UNITED STATES PATENT AND TRADEMARK OFFICE

APPLICATION NO.	FILING DATE	FIRST NAMED INVENTOR	ATTORNEY DOCKET NO.	CONFIRMATION NO.
10/658,316	09/09/2003	Philip Katz		2164
7590 11/10/2005				
Stephen E. Feldman, P.C. 12 East 41st Street New York, NY 10017		EXAMINER MILLER, WILLIAM L		
		ART UNIT 3677 PAPER NUMBER		
DATE MAILED: 11/10/2005

Office Action Summary

DETAILED ACTION

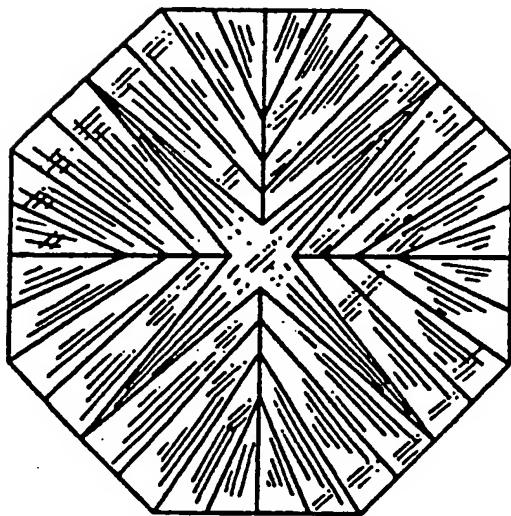
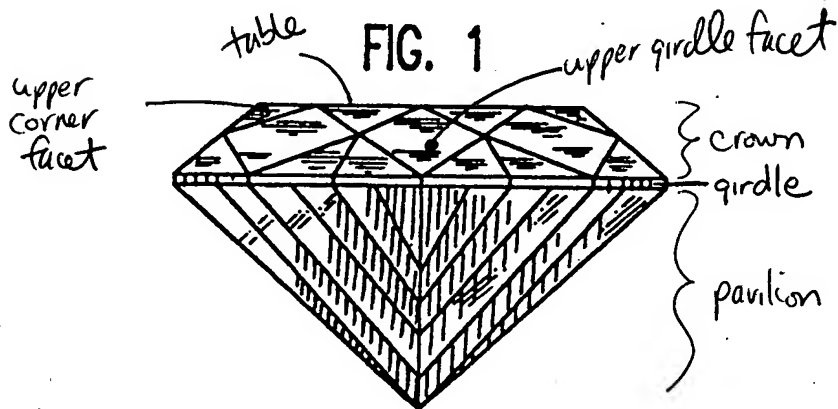
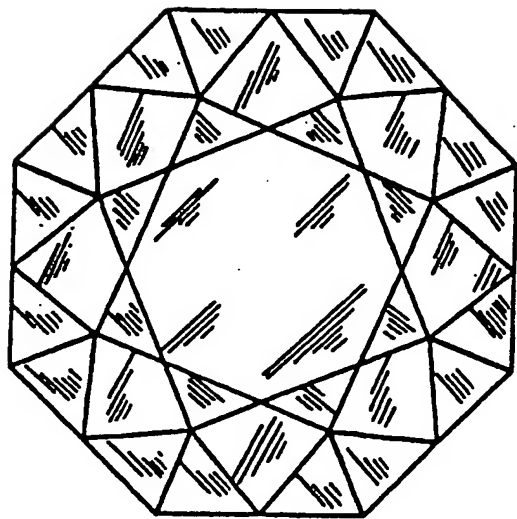
6. Regarding claims 1, 4, and 5, Schachter discloses a brilliant cut gemstone comprising: a brilliant cut crown on an upper side of a girdle including upper girdle facets and upper corner facets; the girdle having plane comprising 8 sides and shaped as an “approximately” equilateral octagon (Fig. 1); the corner facets spaced from the girdle (Fig. 2); and a pavilion located on a lower side of the girdle. Note: See annotated Fig. 2.
